ADDENDUM No. 3

Date August 7, 2015

Project Name Harris Branch Interceptor Lower A and Siphon Line Decommission

C.I.P. No. 4769.010

SHEET
 18
 OF
 47

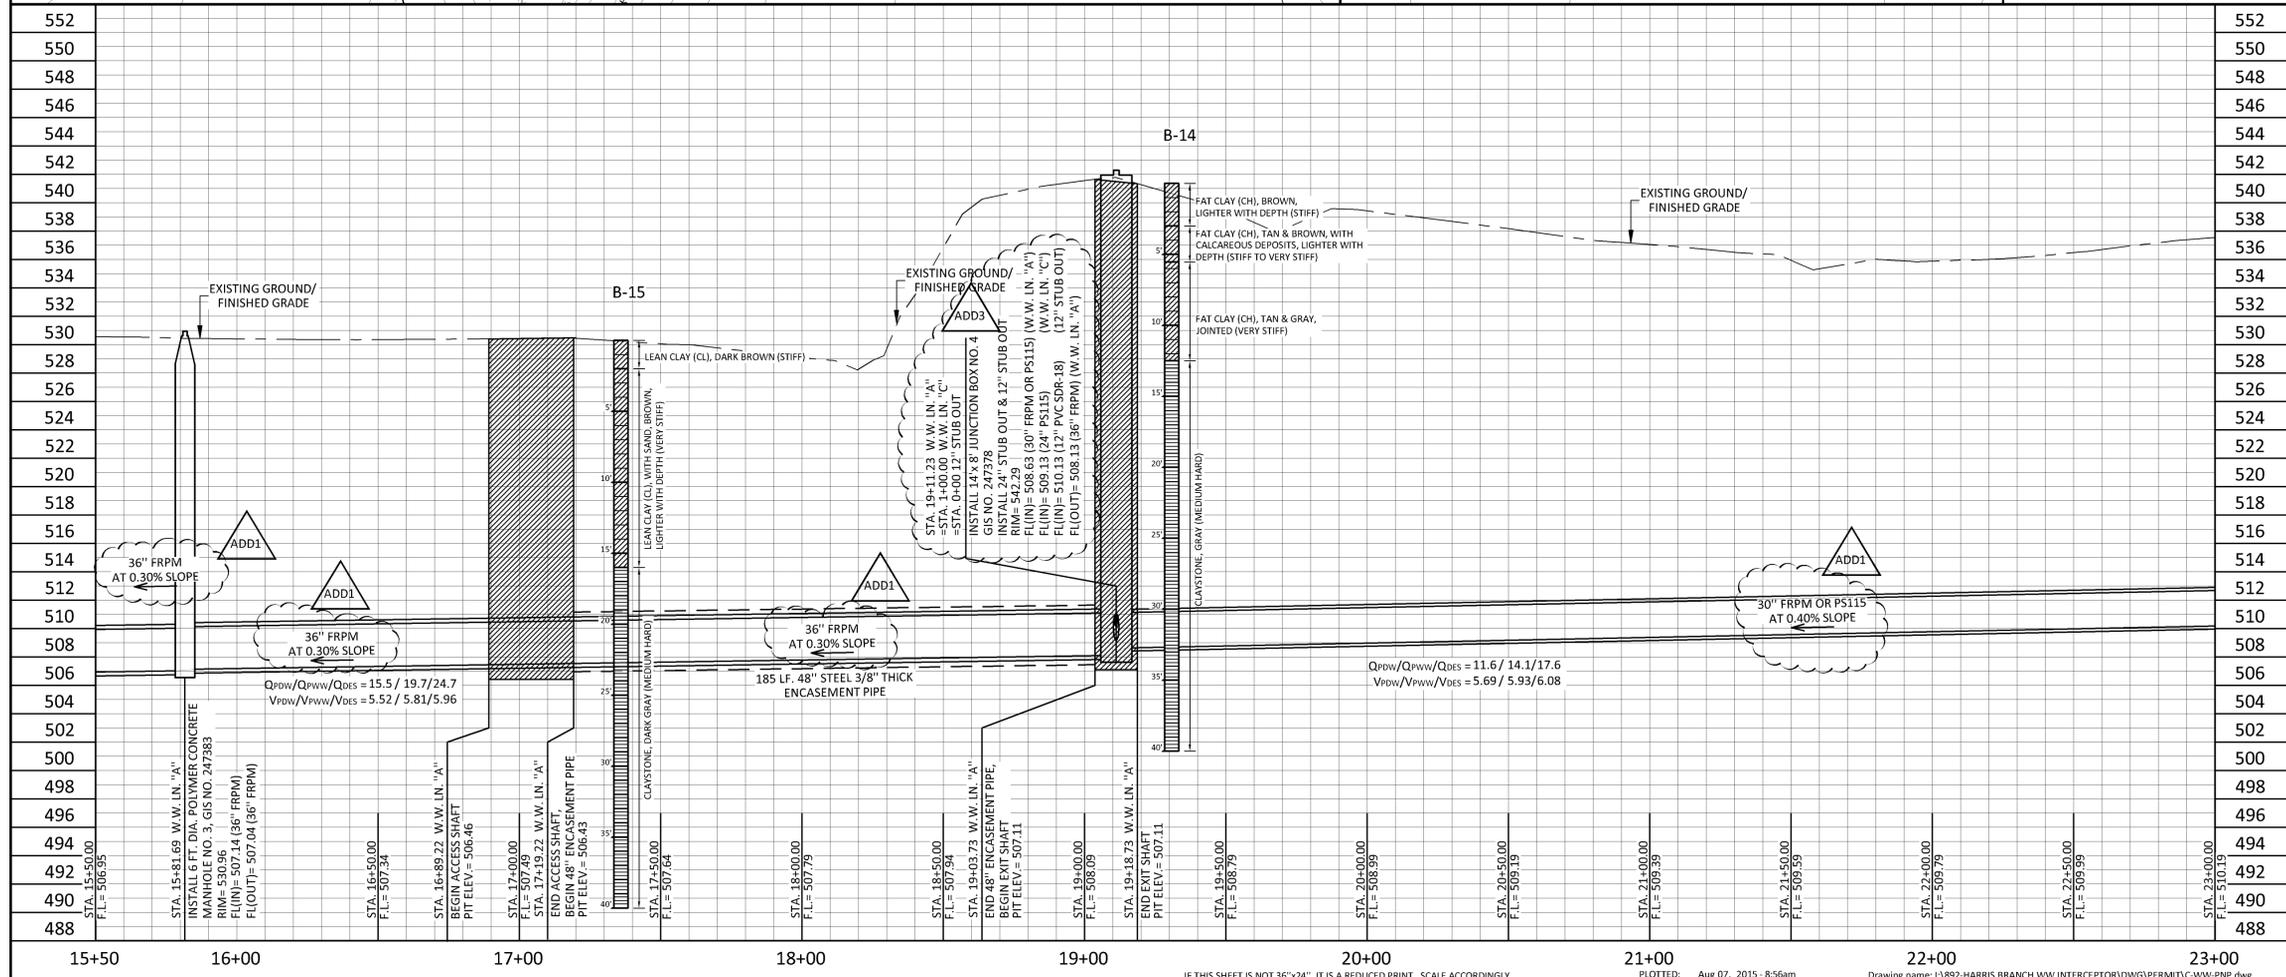
NO.	DATE	APPROVED BY	DESCRIPTION
C1	3/16/2015	TC	REVISED BORE & EXIT SHAFT PROFILES
ADD1	7/20/2015	TC	REVISED ACCESS, REMOVED ALL 'NO' 'TYPICAL' 'PS115', AND REVISED 'M.H. DRAWINGS'
